**A New Facilities Services Maintenance Building for:
Midwestern State University
Wichita Falls, Texas**

BYSP PROJECT NO. 18002

January 17, 2019

ELECTRICAL SITE PLAN

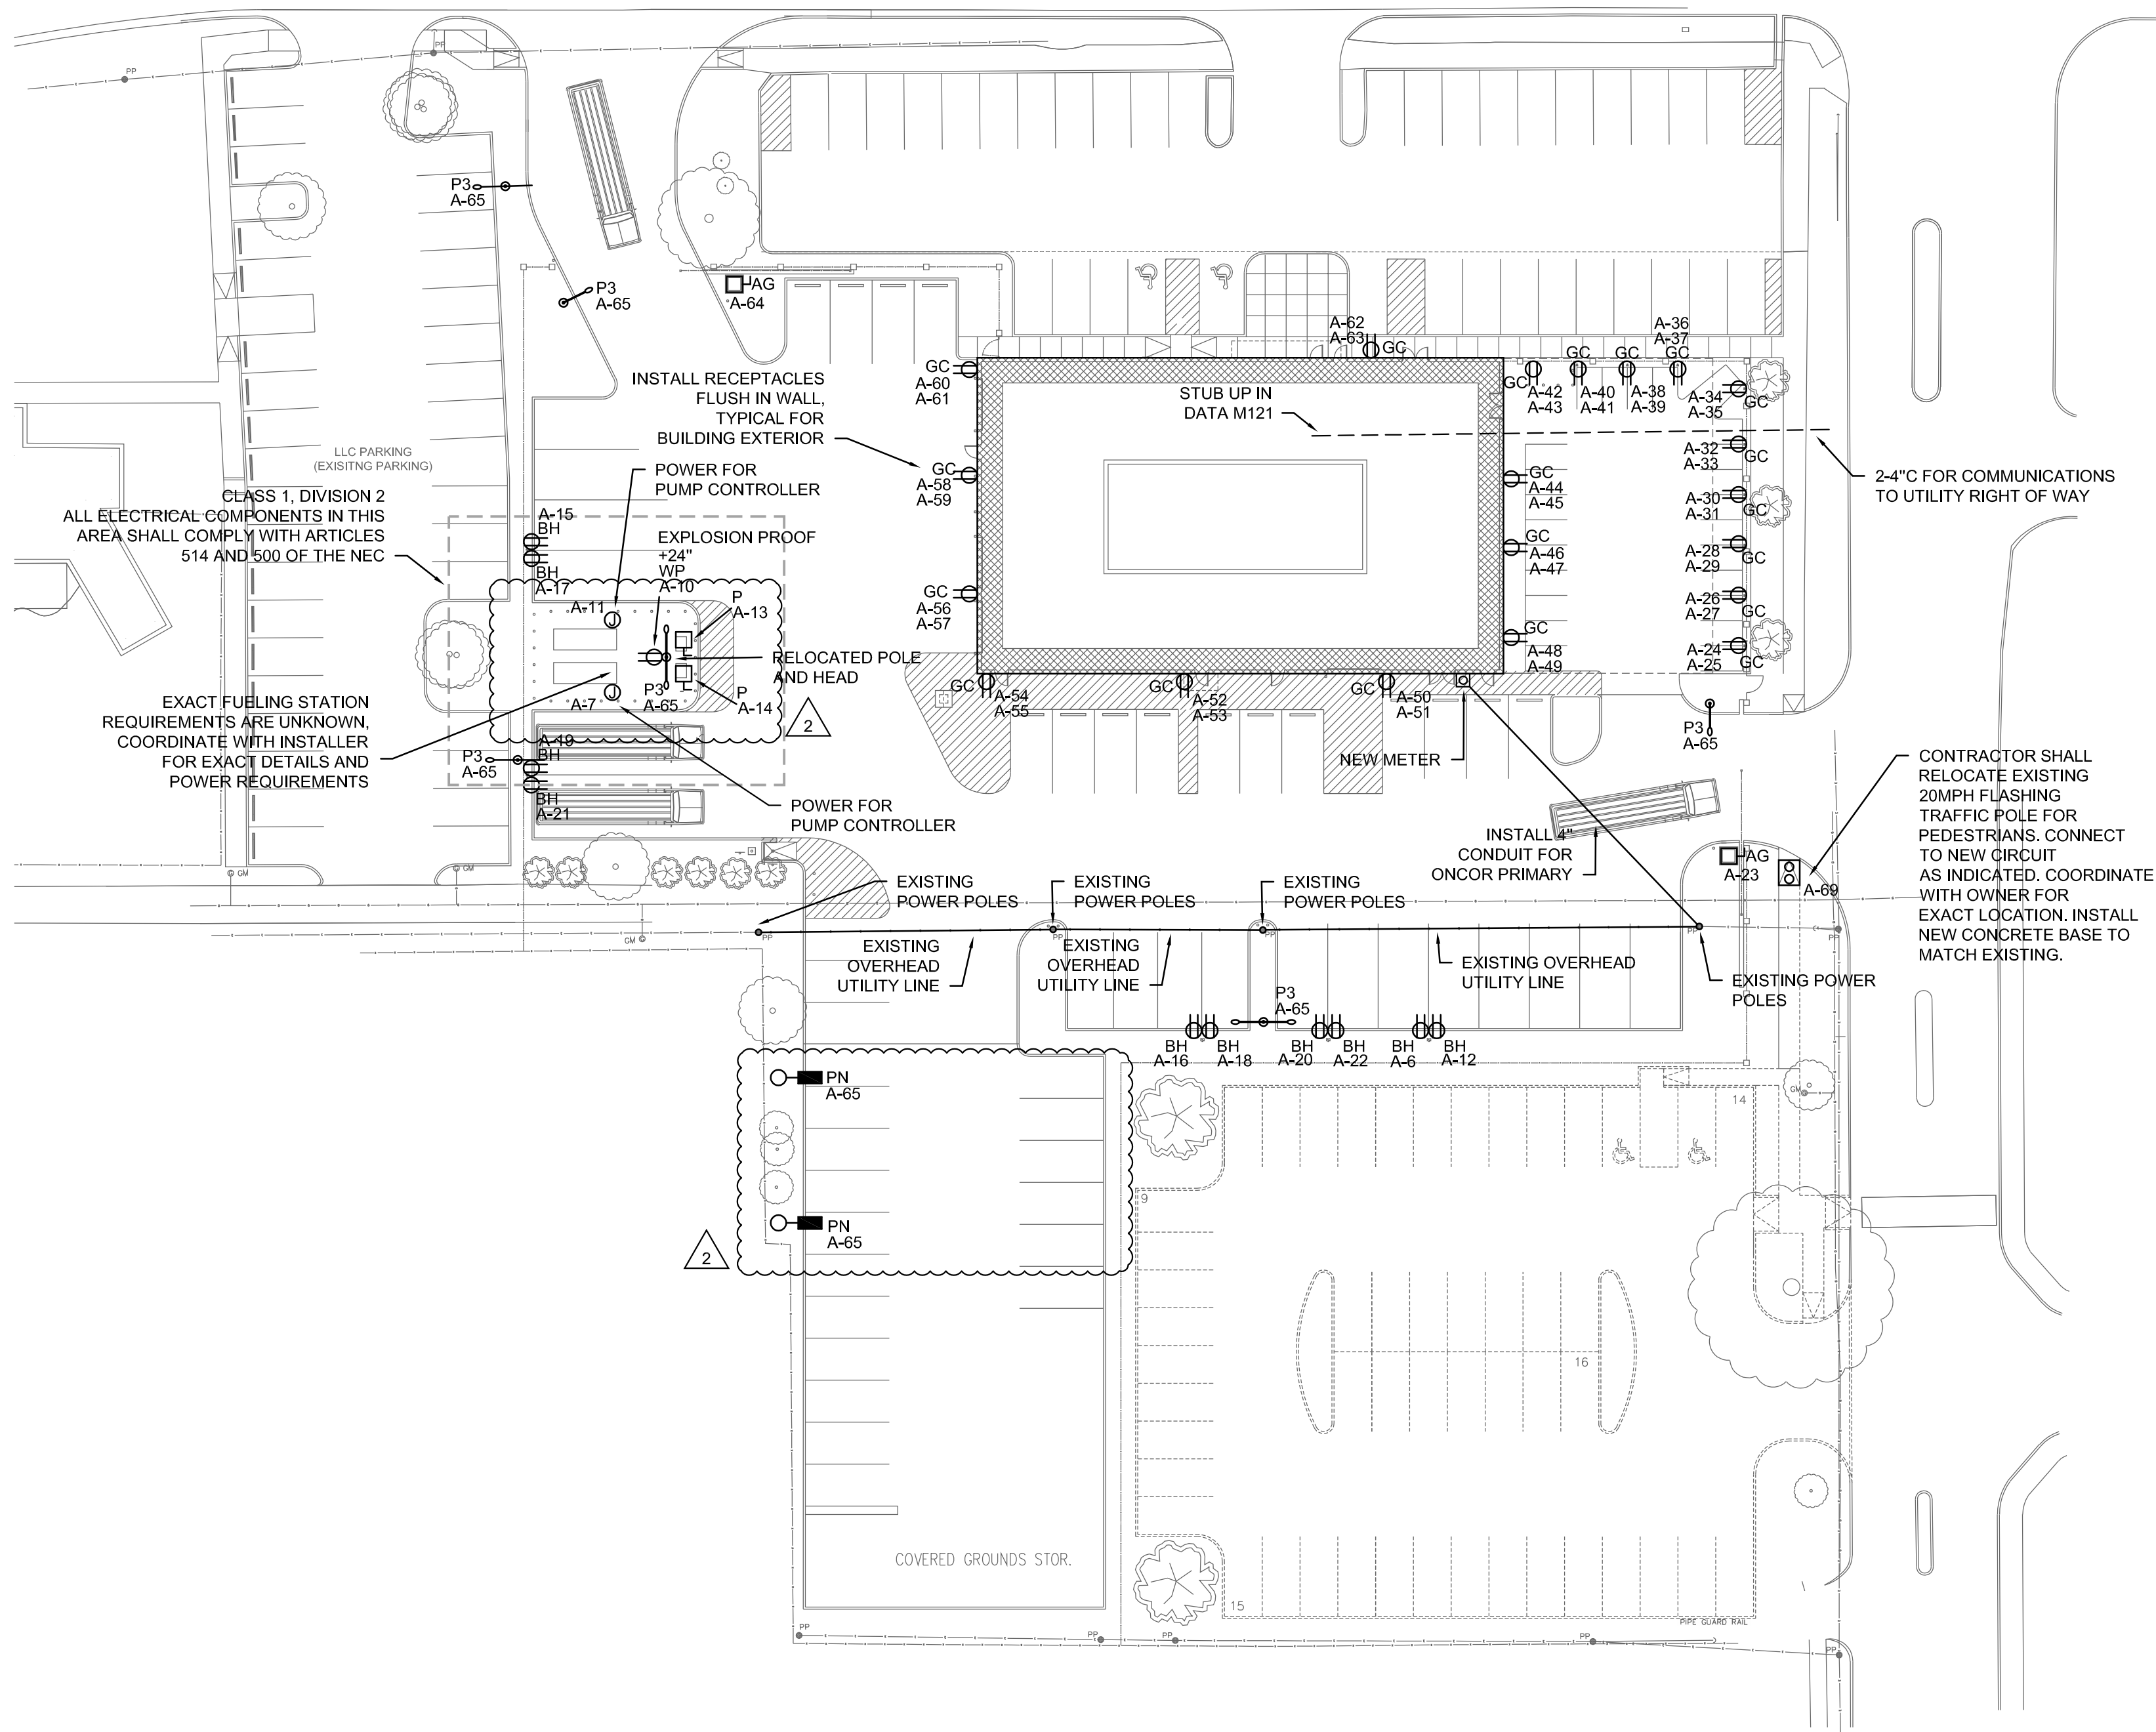
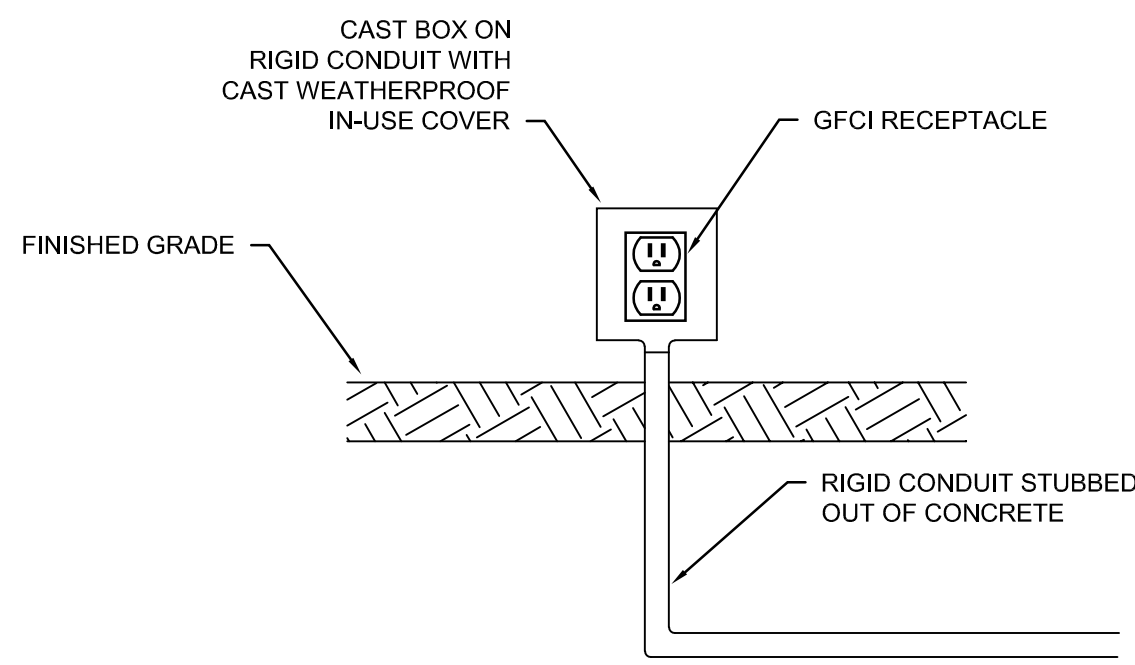
Disregard three locations of Key Note 22 on the east side of the building. Refer Sheet E101 for locations and requirements of electrical outlets for golf cart charging stations.

30. Sheet SP101 shows keynote 22 at 3 locations along east wall of building? Are these locations intended to be charging stations?

Response: Refer Addendum #2

ELECTRICAL FLOOR PLAN
SCALE: 1/8" = 1'-0"

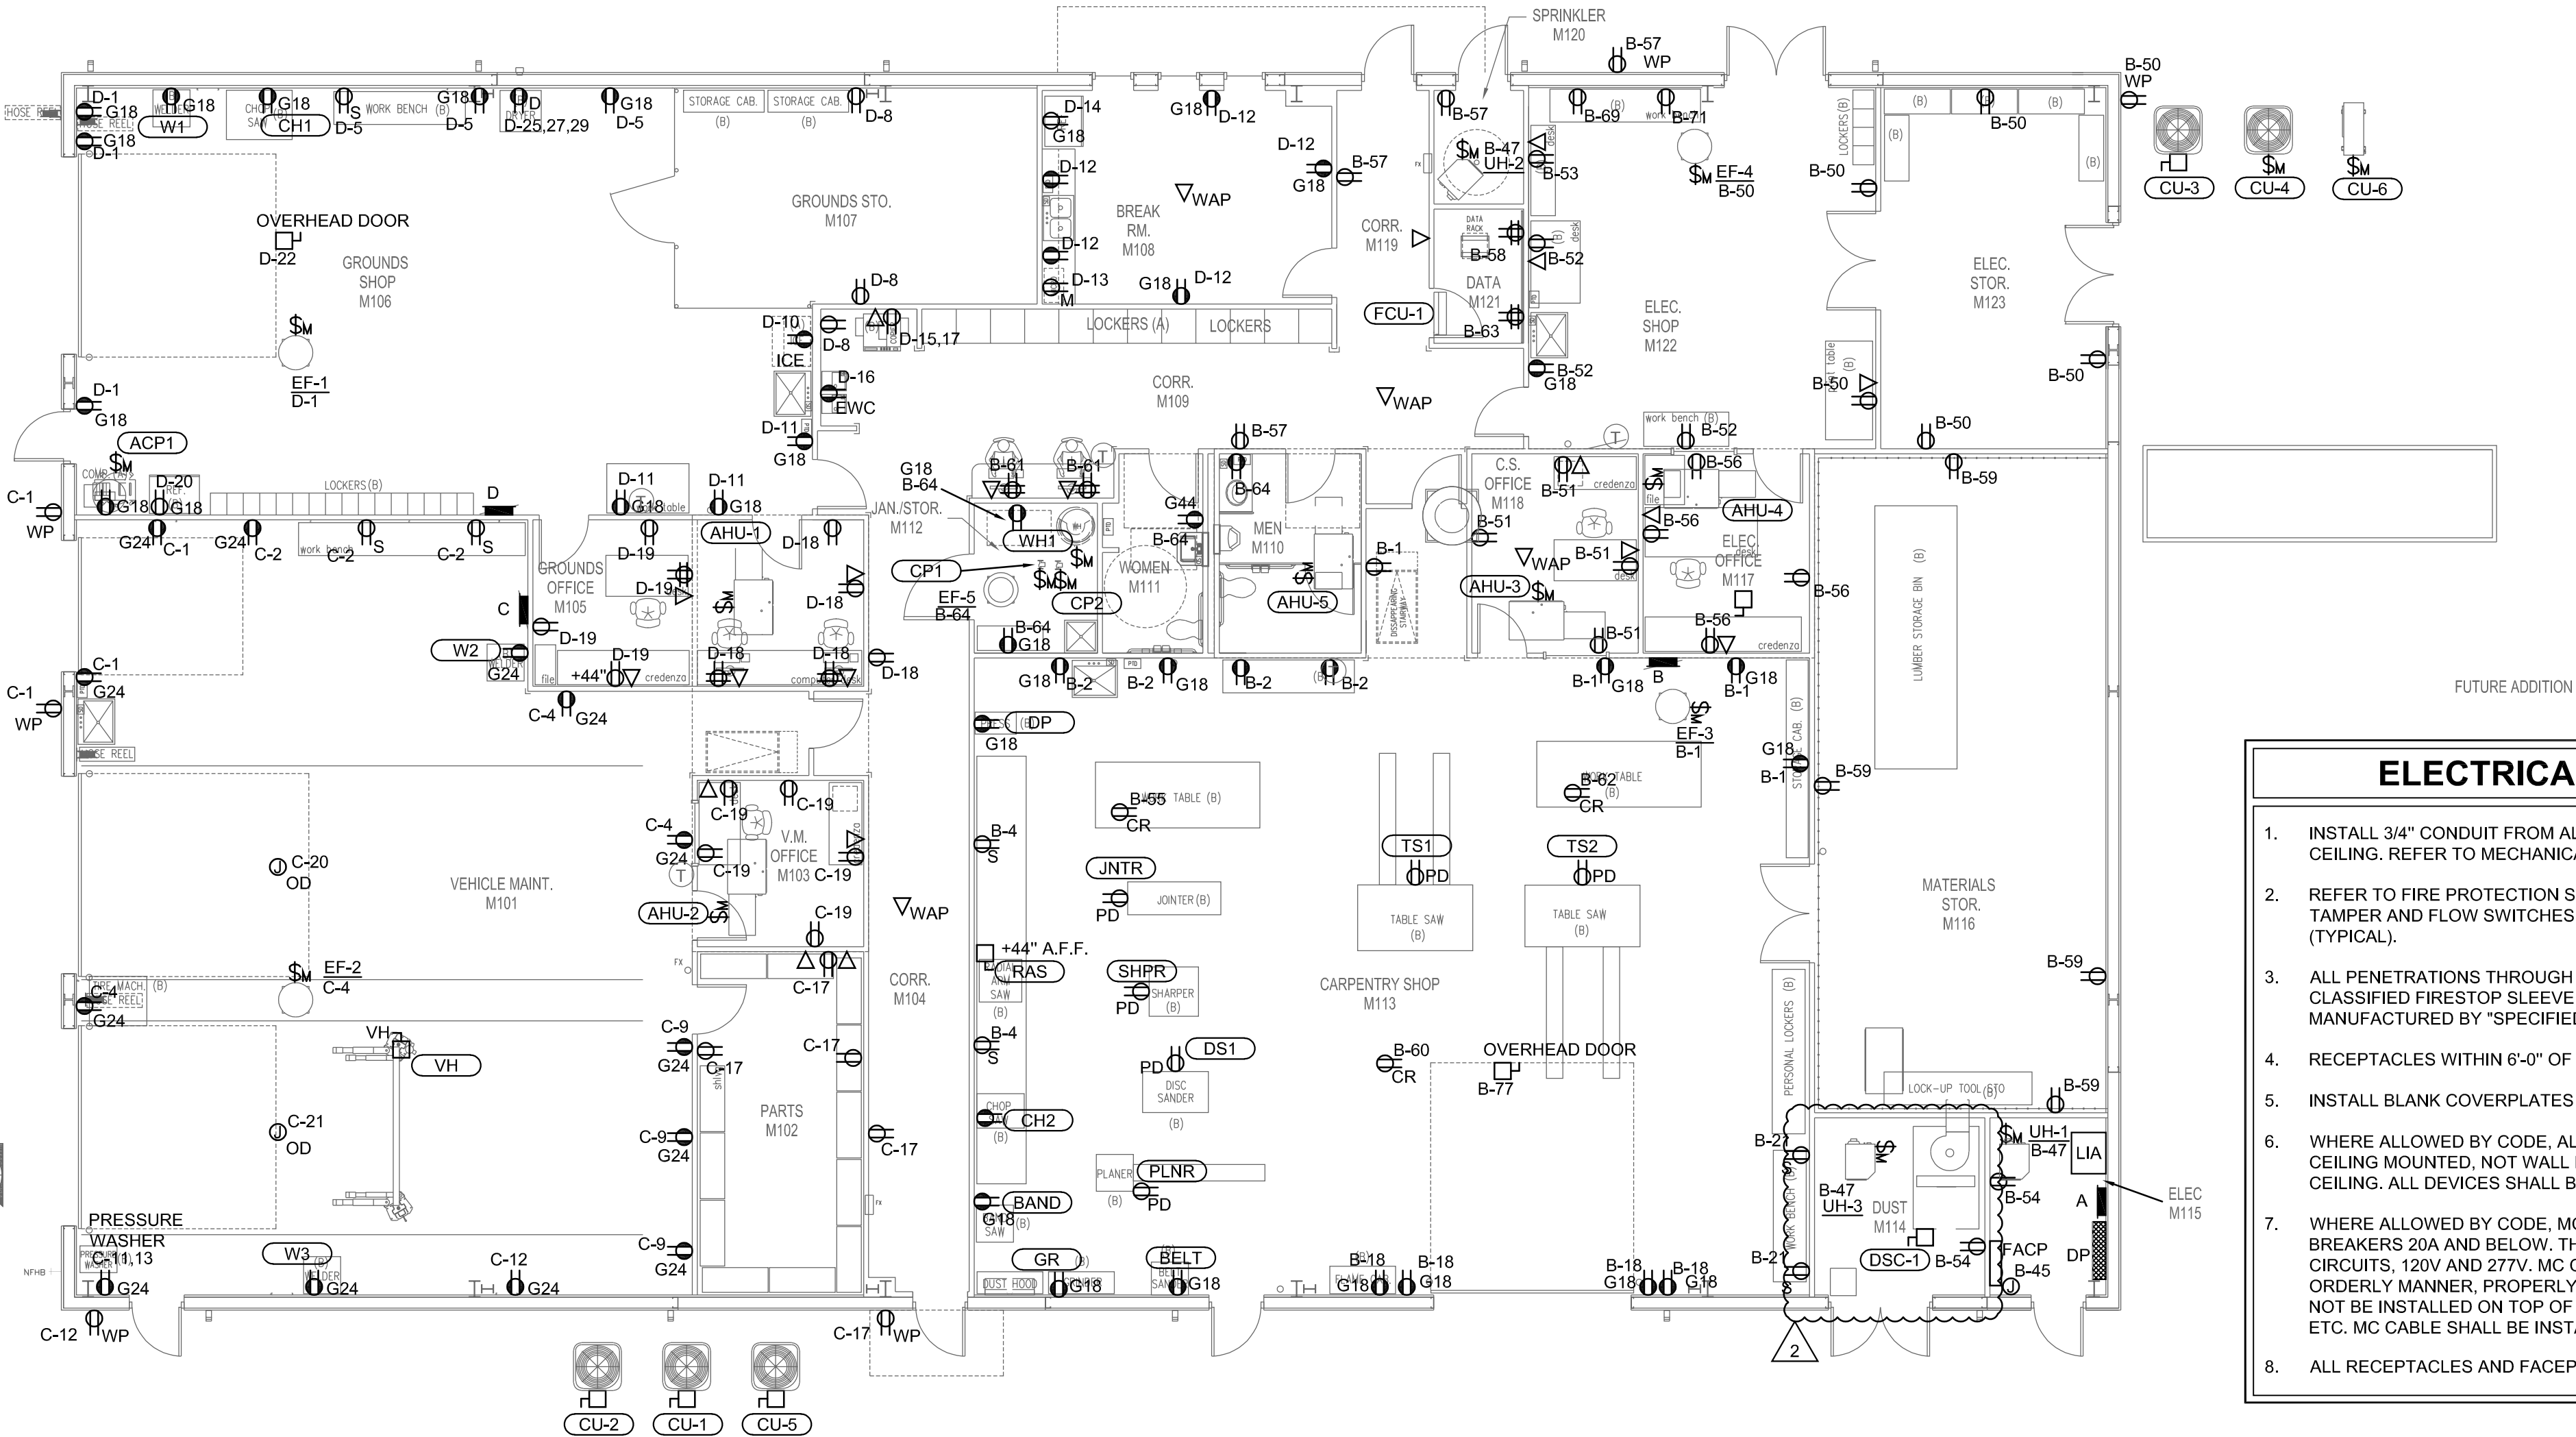
Item No. 17:

Replace Electrical drawings issued 12/11/2018 with the attached drawings listed below and attached to this addendum. Revisions are clouded and mark as Revision # 2

1. E101
2. E301
3. E400
4. E501
5. E502
6. E503
